8. Kinder Subdivision Blake Addition No. 1 KPB File 2023-127 Segesser Surveys / The Homestead, LLC Location: Cohoe Loop Road

ITEM #8 - PRELIMINARY PLAT Kinder Subdivision Blake Addition No. 1

KPB File No.	2023-127
Plat Committee Meeting:	December 11, 2023
Applicant / Owner:	The Homestead, LLC / Kasilof, Alaska
Surveyor:	John Segesser / Segesser Surveys
General Location:	Cohoe Loop Road, Cohoe area

STAFF REPORT

Kinder Subdivision Blake Addition No. 1

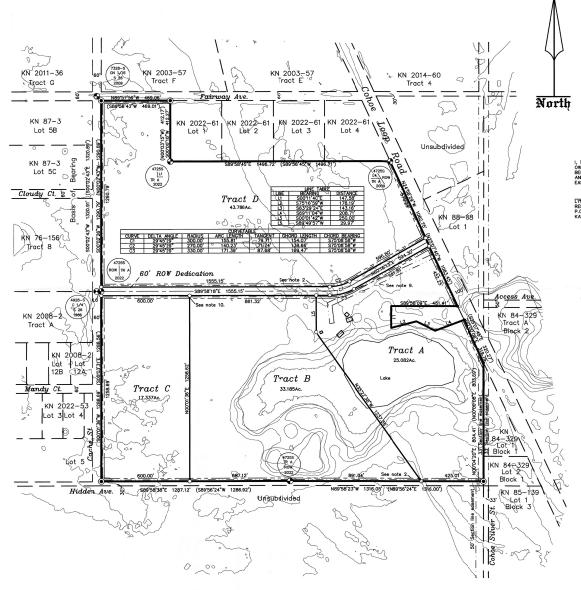
There are no steep areas or drain ways, on the plat. Contours can be removed from the final.

There is an unnamed lake located on the plat that has an area of inundation located to the west of it. There area of inundation is shown, but should be expanded to match KPB imagery showing wetland area to the east and south of what is currently shown on the drawing. Wetlands should be shown on the final along with the lake. **Staff recommendation**: place a note on the final plat indicating any person developing the property is responsible for obtaining all required local, state, and federal permits, including a U.S. Army Corps of Engineers wetland determination if applicable.

10- foot utility easements are proposed along the rights-of-ways. **Staff recommendations:** add more labels of the "See note 10" to the drawing. Adjust the note in the northwest corner of Tract B as the identifier is confusing with its pointer and the pin mark and lot line.

There are electric easements identified on the drawing and listed in the notes from the certificate to plat. **Staff recommendations:** the point for See note 9 in Tract A1 needs moved as it is confusing in its positioning. HEA has given notice this easement can be reduced to 15 feet.

Add to the KBP No. 2023-127 Adjust plat note numbering.

Add 'Unnamed' to the lake inside the property,

Add more "See note 2" to the drawing.

Add a distance across the front of the deeded tract.

Add to the legend line for the 20' setback, utility easements, area of inundation

Show and label Rilinda Road to the east including right-of-way.

Label Shiak Street to the east including right-of-way.

Label the right of way of Hidden Avenue to the west.

Lots near Rilinda Road need labeled.

Low wet areas shown, but there appears to be more to the south of what is shown that need to be added per KPB Data.

In the line table, L1 – L4 should have both measured and recorded data.
